Access Compliance Report

Public Rights-of-Way

(Pedestrian Signals)

Intersection ID: N/A	Main Street:	Cross Street: N/A	Location: N/A
ADA ID: 055926EA3A33	Signal Type: Two Push Buttons-APS	Overall Compliance: No	Severity Score: BTN 1:N/A BTN 2: N/A No BTN: N/A
Codes/Mitigation Info/Possible Solution		Field Measurements/Component Compliance

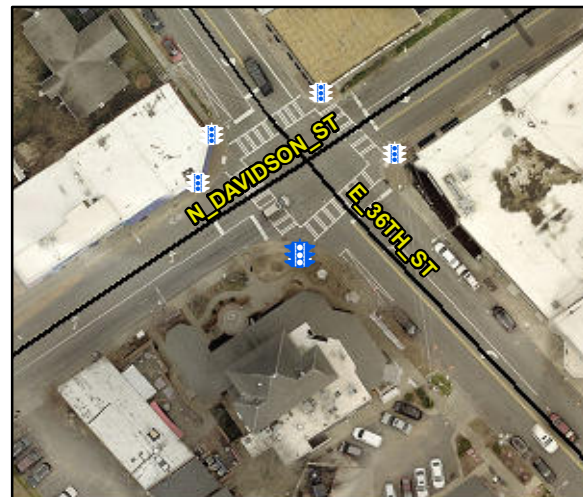
Surveyor Notes: TEXT HT 3/8

PROW/ADA: R410.6, TMUTCD 4e.08, R404.2, R406.2, R404.7.3,

Possible Solutions: Replace Signal Push Button With APS Button on New Post. Remove & Replace Sign.
